From: [Tom Turnquist](#)
To: [Urban Design Comments](#)
Subject: Vilas park master plan
Date: Tuesday, December 1, 2020 3:19:06 PM

From: [Tim Chapman](#)
To: [Urban Design Comments](#); [Vilas Master Plan](#); [Evers, Tag](#); [Knepp, Eric](#); [Freiwald, Ann](#); [Wendy Fernside VNA Board member and Vilas Park rep](#); [Ann Rivlin VNA Vilas Park rep](#); [Sarah Bahauddin VNA pres](#)
Subject: Vilas Park Master Plan (VPMP) comments
Date: Wednesday, December 2, 2020 3:15:09 PM

Please see my comments below to the DRAFT Vilas Park Master Plan presented by MSA and the Parks Department staff at the Community Input #3 Meeting on 11/16/20:

Here is the present view from Campbell Street near my driveway:

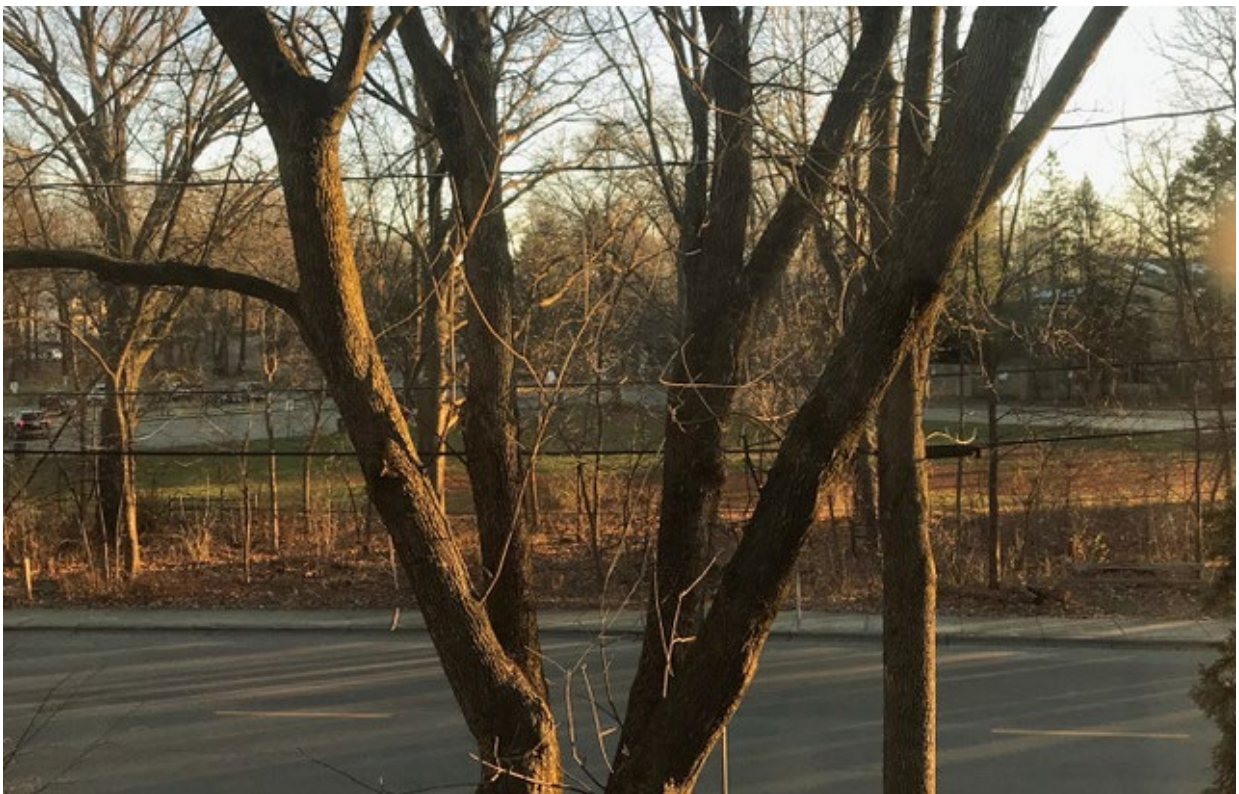
I hope you will oppose the parts of the proposed Vilas Park relating to the area near Drake Street, in particular the proposed new entrance/exit and expanded parking.

As you can see, it would replace an edge-of-town view with a highway view. It would mean the loss of many trees, some large and some that could grow large in time. It would make it easy for drivers leaving the park to go straight up Campbell Street to Bear Mound Park, with its historic burial ground and narrow street—not a good place for heavy traffic..
